<b>Title - Sujet</b> Const. (Phase 2)-Green Gables, PEI	
<b>Solicitation No. - N° de l'invitation</b> ED001-181274/A	<b>Amendment No. - N° modif.</b> 006
<b>Client Reference No. - N° de référence du client</b> R.081199.001	<b>Date</b> 2017-10-13
<b>GETS Reference No. - N° de référence de SEAG</b> PW-SPWC-024-4190	
<b>File No. - N° de dossier</b> PWC-7-40074 (024)	<b>CCC No./N° CCC - FMS No./N° VME</b>
<b>Solicitation Closes - L'invitation prend fin</b> <b>at - à 02:00 PM</b> <b>on - le 2017-10-18</b>	<b>Time Zone</b> <b>Fuseau horaire</b> Atlantic Daylight Saving Time ADT
<b>F.O.B. - F.A.B.</b> <b>Plant-Usine:</b> <input type="checkbox"/> <b>Destination:</b> <input checked="" type="checkbox"/> <b>Other-Autre:</b> <input type="checkbox"/>	
<b>Address Enquiries to: - Adresser toutes questions à:</b> Bysterveldt (PWC), Crystal	<b>Buyer Id - Id de l'acheteur</b> pwc024
<b>Telephone No. - N° de téléphone</b> (902) 940-7122 ( )	<b>FAX No. - N° de FAX</b> (902) 566-7514

THIS ADDENDUM IS RAISED TO PROVIDE THE FOLLOWING ANSWERS TO QUESTIONS PROVIDED BY BIDDERS.

**GREEN GABLES—PHASE 2  
BARN EXPANSION  
AND RENOVATION**

SSK-05 K.081199.001 no. du dessin drawing no.

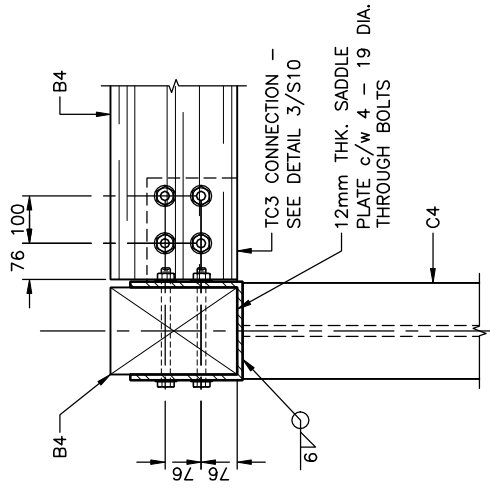
4. **Question:** What are the connection details for the members of the two entry canopy structures between gridlines 9 and 10, as seen on EL9/S06 and on S03?

**Answer:** Reference Drawing S03 –Roof Plan. At the entry canopies add note TC34 for connection of the B4 beam to the column, see attached SSK-05 for connection detail.

Submission  
PWSSC Project Manager  
Administrateur de projet TPSSC  
project number  
**R.081199.001**  
drawing no.  
**SSK-06**

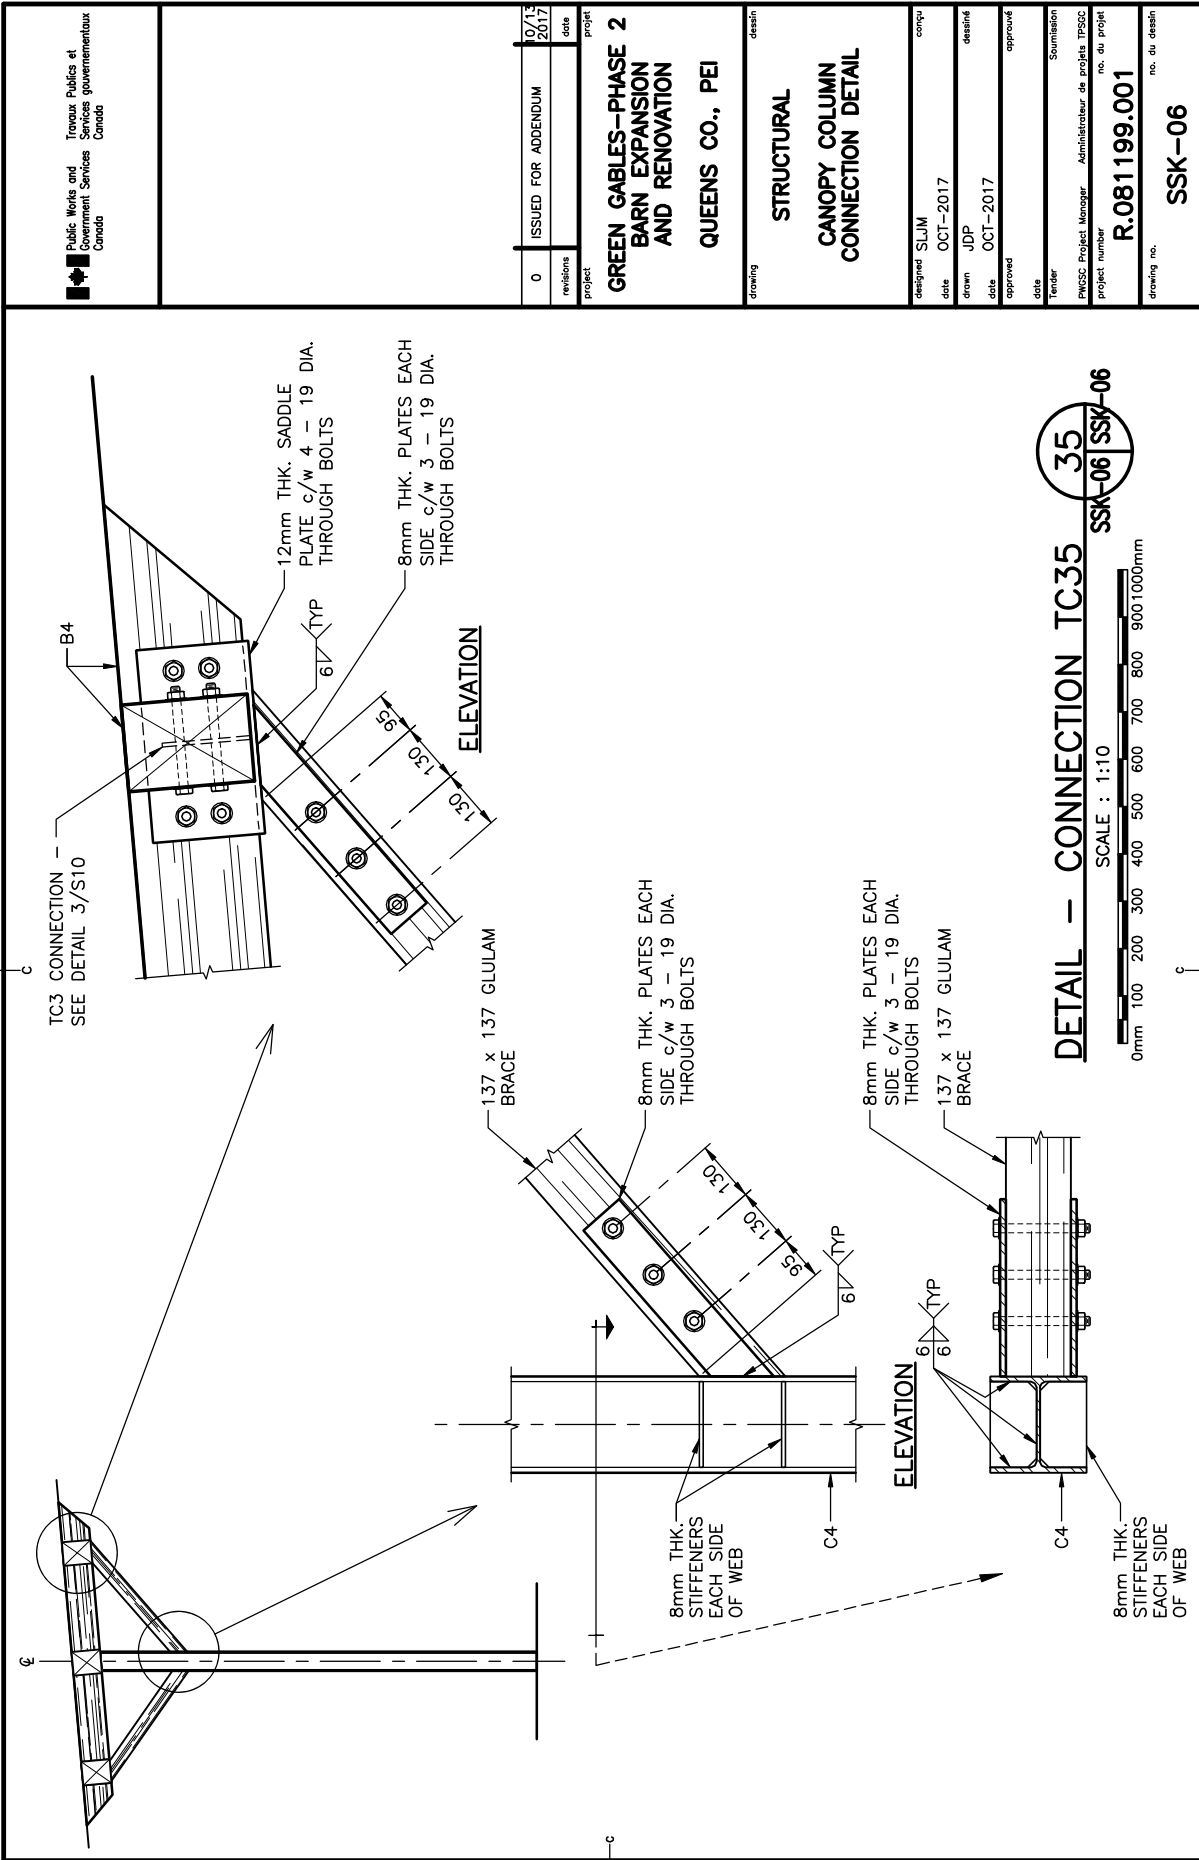
5. **Question:** Are the 137x137 members in the entry canopies HSS, glulam, solid timber or other? Please provide connection details.

- a. Add note TC35 for connection of 137x137 brace B4 beam and brace to column. See attached SSK-06 for connection details.
- b. Revise call out for brace to: 137x137 Glulam brace.
